# TECHNICAL SERVICE BULLETIN

Bulletin Number: V-15-03  
Model Years: 2015

**SUBJECT:** 2015 Victory Motorcycles – Idle Air Control Replacement / ECM Reflash

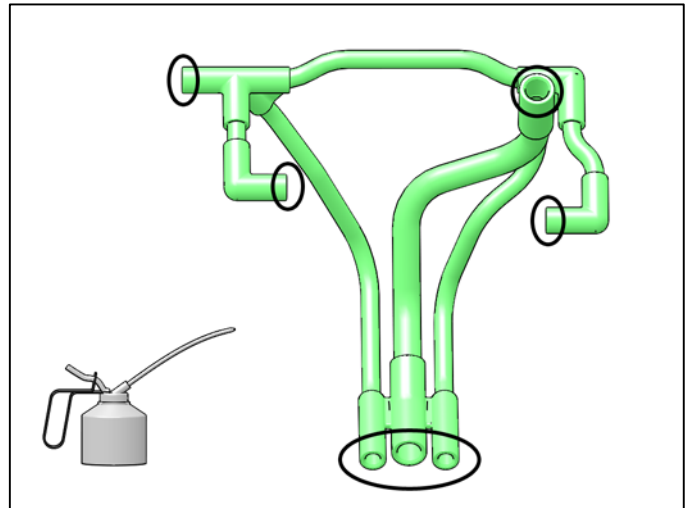
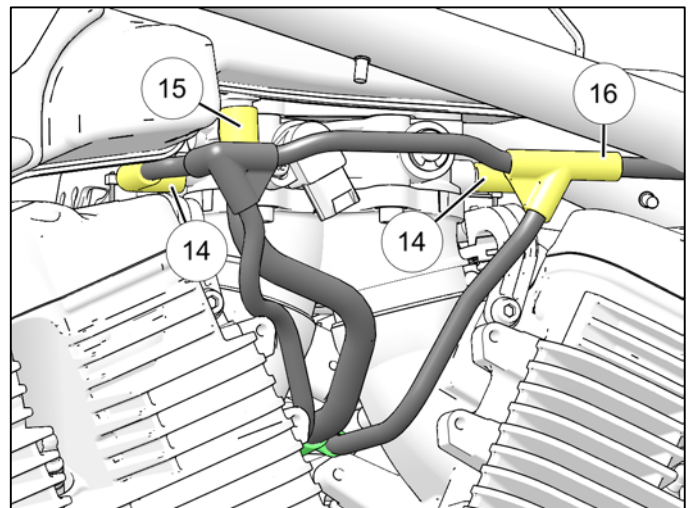
15. Apply P80 (or similar) lubricant to hose connections on the new IAC hose bundle.

16. Feed the IAC hose assembly through the engine from the primary cover side and connect the front and rear throttle body fittings ⑭, the air box fitting ⑮ and the charcoal canister fitting ⑯.
